**NUREG-1560**  
**Vol. 3**

# **Individual Plant Examination Program: Perspectives on Reactor Safety and Plant Performance**

**Part 6**

**Appendices A, B, and C**

Figure C.1 Comparison of NUREG-1150 and Westinghouse seal LOCA models — old o-ring elastomer.

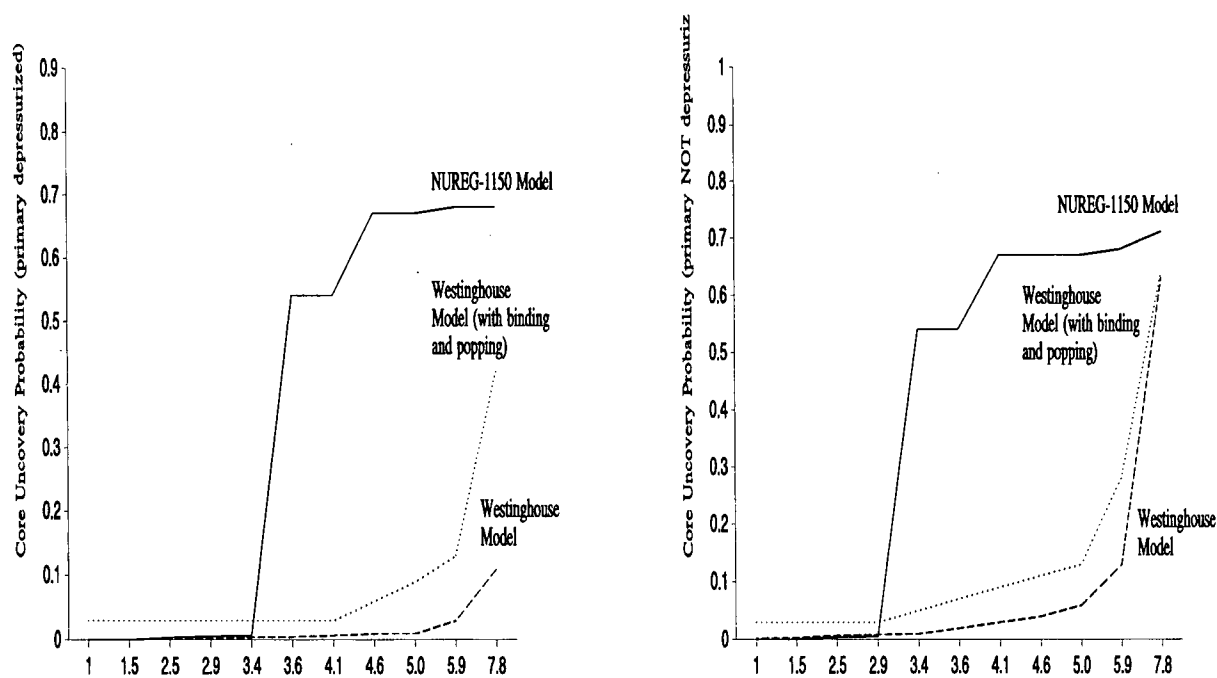
11. **Comment:** It is not clear from the information presented that the Westinghouse RCP seal LOCA model provides a lower contribution to CDF than the IPEs that used the NUREG-1150 model.

Since this is very important to many plants, it is recommended that NUREG-1560 provide a detailed comparison of the two approaches. One of the dominating factors in the seal LOCA model is the probability of core uncover occurring within the first hour. IPEs using the Westinghouse RCP seal LOCA model typically use 0.0283 and the NUREG-1150 model uses 0.0. The NUREG-1150 model does not consider any seal leakage for the first 90 minutes. From these facts it appears that the Westinghouse RCP seal LOCA model is more conservative. (Reference: see Table C.1, #16)

A comparison of the seal LOCA probabilities from the two models was not possible due to the unavailability of the reports documenting the Westinghouse model (with and without seal binding and popping open included). However, the Point Beach IPE and the response to questions concerning the Farley IPE did provide

an opportunity to compare the core uncover probability as a function of time for cases involving RCPs equipped with the old o-ring elastomer with the vessel either depressurized or not depressurized, and with the RCPs tripped. A comparison of the values from these curve fits with the core uncover times calculated for identical cases for the Surry plant, as reported in NUREG-1150, Volume 3, is provided in Figure C.1. The curve fit is only valid over the time frame of 30 minutes to 8 hours. It should be noted that Point Beach is a two loop plant

while Surry and Farley are three loop plants and thus the core uncover time for a given leak rate could be different. However, since the reactor coolant system volumes for the plants are roughly scaled by the number of coolant loops, the core uncover times for three plants for the same amount of leakage from each pump should not be substantially different. Thus, the core uncover probability comparison in Figures C.1 provides a reasonable picture of the differences between the NUREG-1150 and Westinghouse seal LOCA models.

Figure C.1 indicates that all three models predict small probabilities of leaks and core uncover for early times (less than about 3 hours). Because of this, differences between the three models do not have a significant impact on CDF for this early time period. However, for later times, the differences are more significant. The Westinghouse models generally predict much
